SUBJECT: Transmittal of Revised Responses to AP1000 DSER Open Items

AP1000 Design Certification Review  
Draft Safety Evaluation Report Open Item Non-Proprietary Responses

**DSER Open Item Number:** 3.8.2.1-1 Revision 2

**DSER Open Item Number:** 19.1.10.1-5 (Response Revision 2)

Fi Figure 19.1.10.1-5e-6- 2: CMT Level for 2-inch Hot Break Leg PRA Case - NOTRUMP

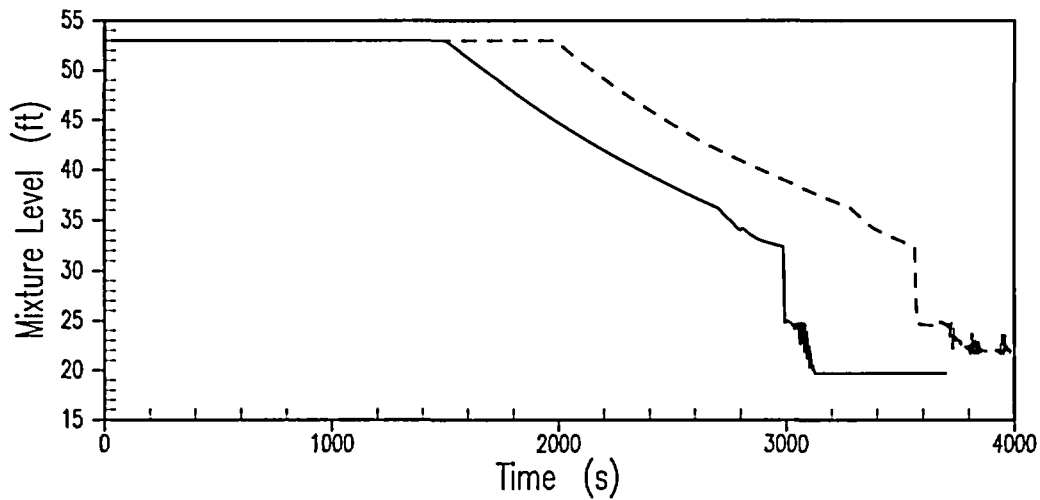
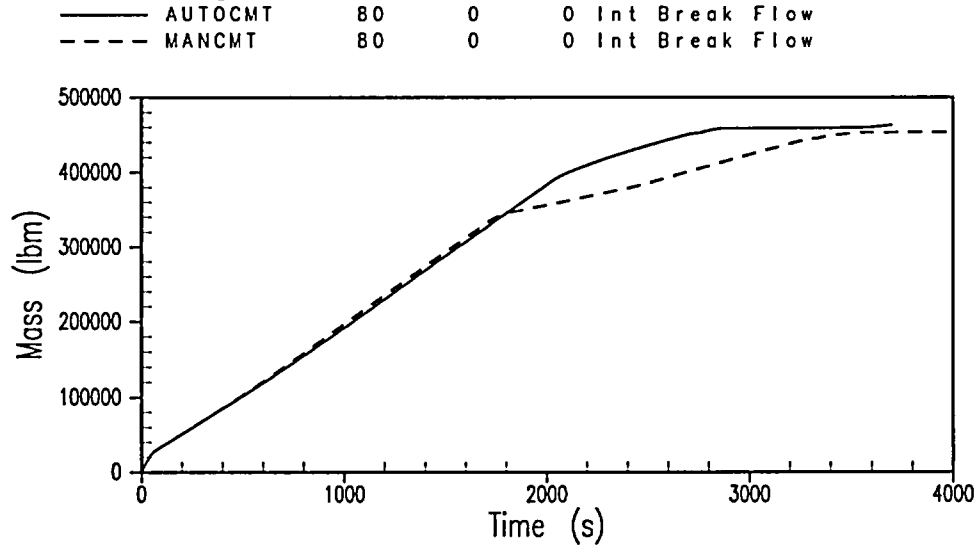
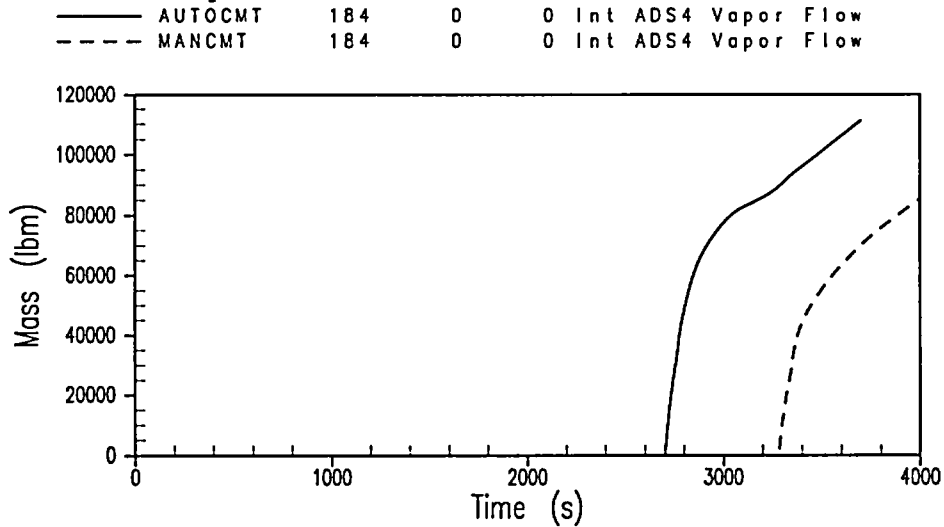
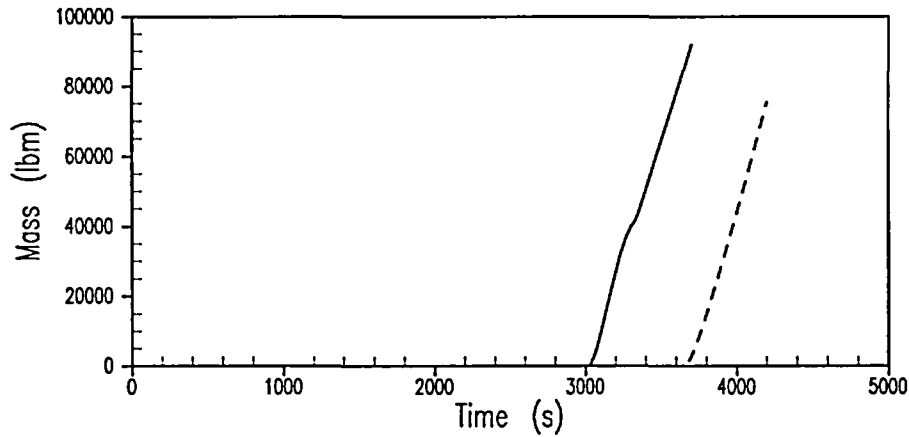
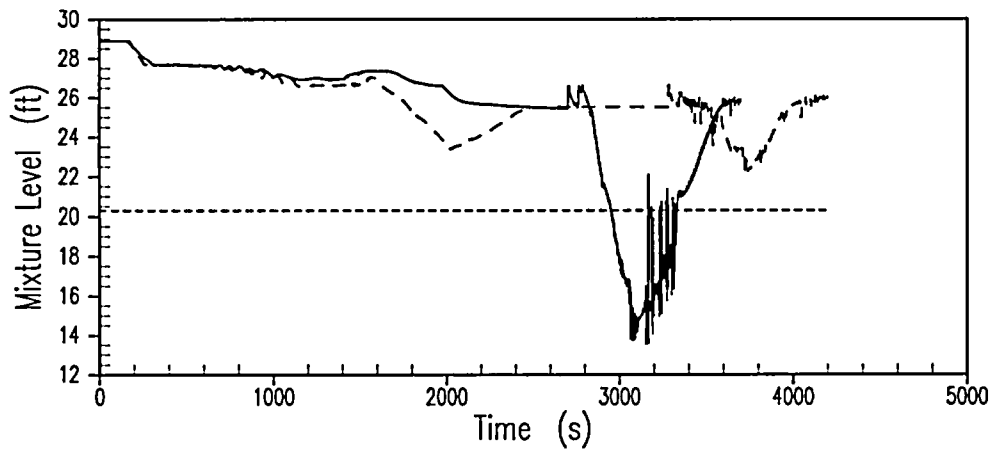
- (e) Additional justification should be provided that evaluations made for AP600 are appropriate to be used in the AP1000 PRA Table 6-1 and in the response to RAI 720.025 where Westinghouse assumes that 30 minutes of core cooling is available following a small break LOCA, steam generator tube rupture or transient with no accumulator injection (RAIs 720.024 and 720.025):

- (e) The case in question (2 inch break, 1 CMT, 0 ACC, 0 ADS1-3, 0 PRHR, ¾ ADS4) has now been performed using NOTRUMP, for automatic CMT actuation and for manual CMT actuation. Comparison plots of these two NOTRUMP cases are shown in Figures 19.1.10.1-5e-1 through 19.1.10.1-5e-6. For the automatic CMT case the CMT draindown starts earlier and leads to earlier actuation of ADS4. For the automatic case the CMT

Figure 19.1.10.1-5g-1

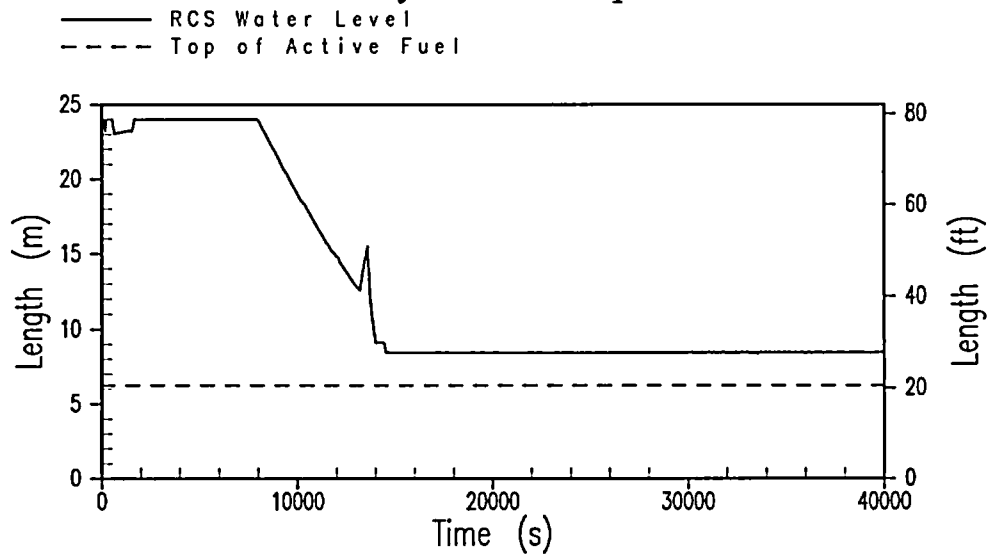
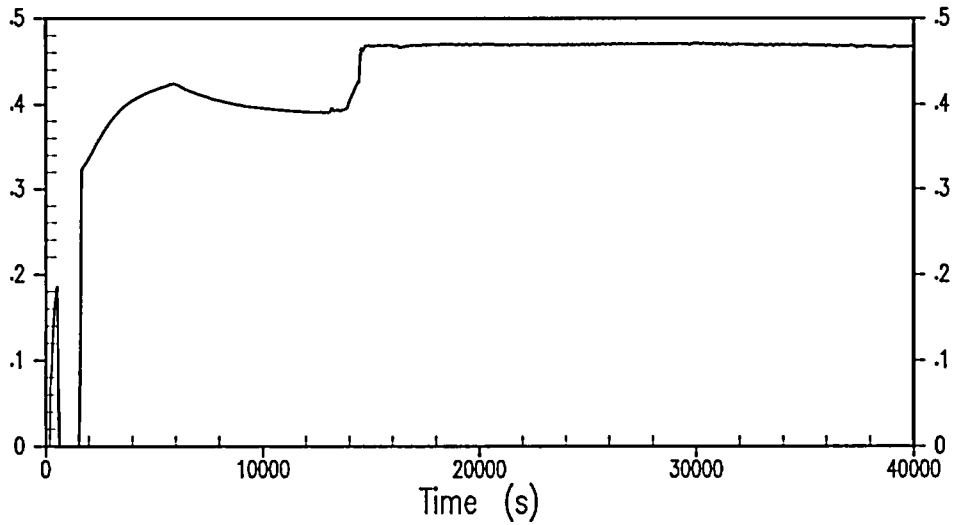
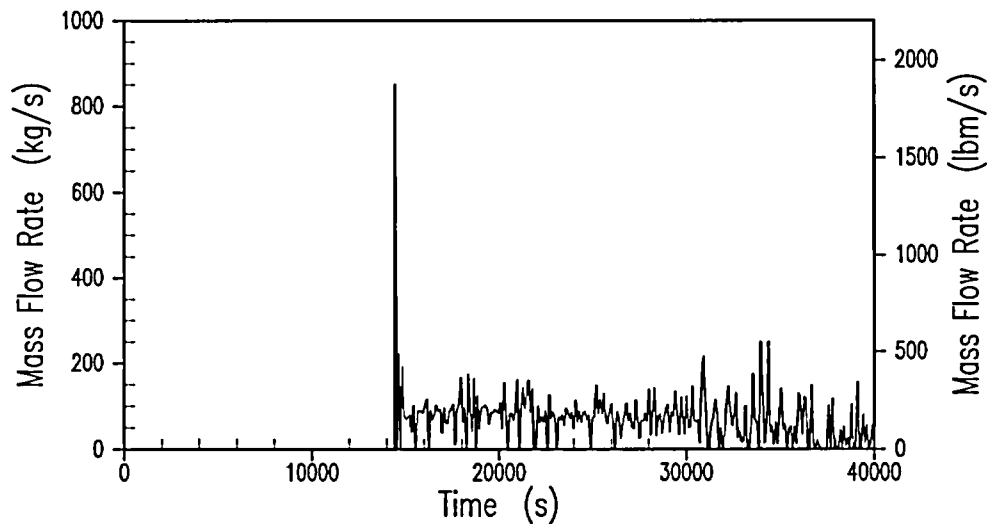
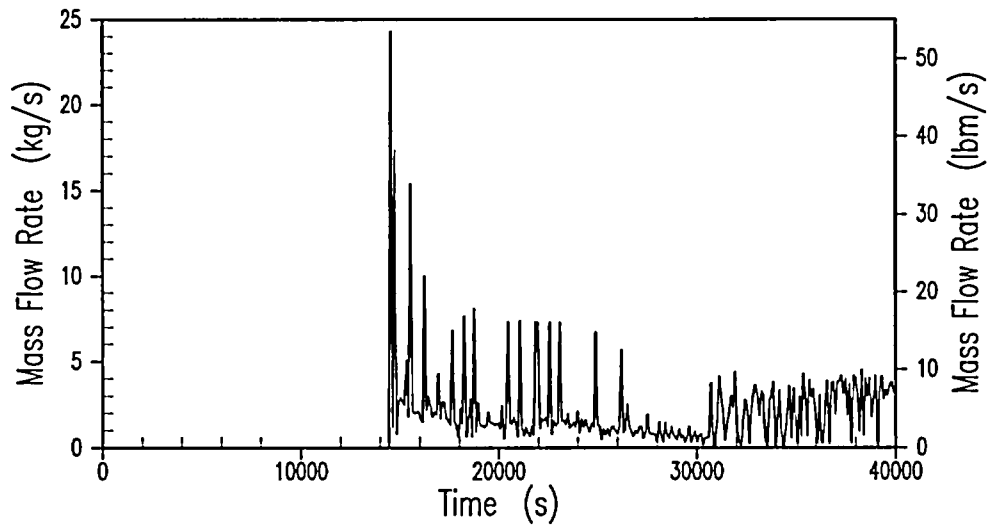
In light of Open Item 19.1.10.1-5 and the concern described in the DSER that MAAP4 does not provide a rigorous solution of reactor system conditions during transients and accidents, the staff requests that Westinghouse confirm the beyond-design-basis MSGTR results of no core uncover described in response to RAI 440.043 with a methodology reviewed by the staff.

For both AP600 and AP1000, Westinghouse has submitted results of the analysis of a multiple steam generator tube rupture. For both AP600 and AP1000, there is a large margin to core uncover, and the results have been accepted for the purpose of demonstrating the plant response to this beyond design basis accident. The previous analysis results provided for AP1000 did not identify the top of the active fuel, and the staff was unable to assess the large margin in the analysis results. The attached figures 19.1.10.1-5g-1 through 4 show the results of the multiple steam generator tube rupture for AP1000. The MAAP4 code is applied appropriately for this large margin case.
